**Amendment and Response**

Serial No.: 10/621,925

Title: ALTERNATING VOIDED AREAS OF ANTI-PADS

**Fig. 2**

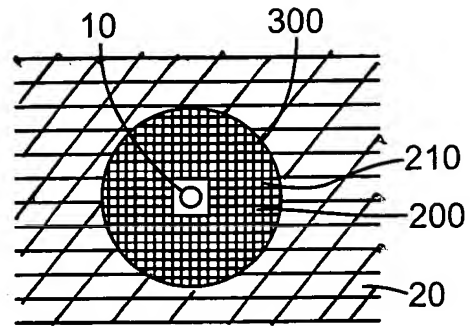
The Drawings are objected to because the sectional views are not properly cross-hatched. Figures 2, 4, 5-8, and 10 have been amended to show proper cross-hatching. Drawing elements 10, 30, 200, 200', 210, 210', 220, 300, 400, 400', 500, 500', 600, and 600' have not been cross-hatched to more easily distinguish those element features. Therefore, Applicants respectfully request that the objection to the drawings be withdrawn.

Please amend Figures 2, 4-8, and 10. Marked up Figures and replacement Figures are attached to this response.
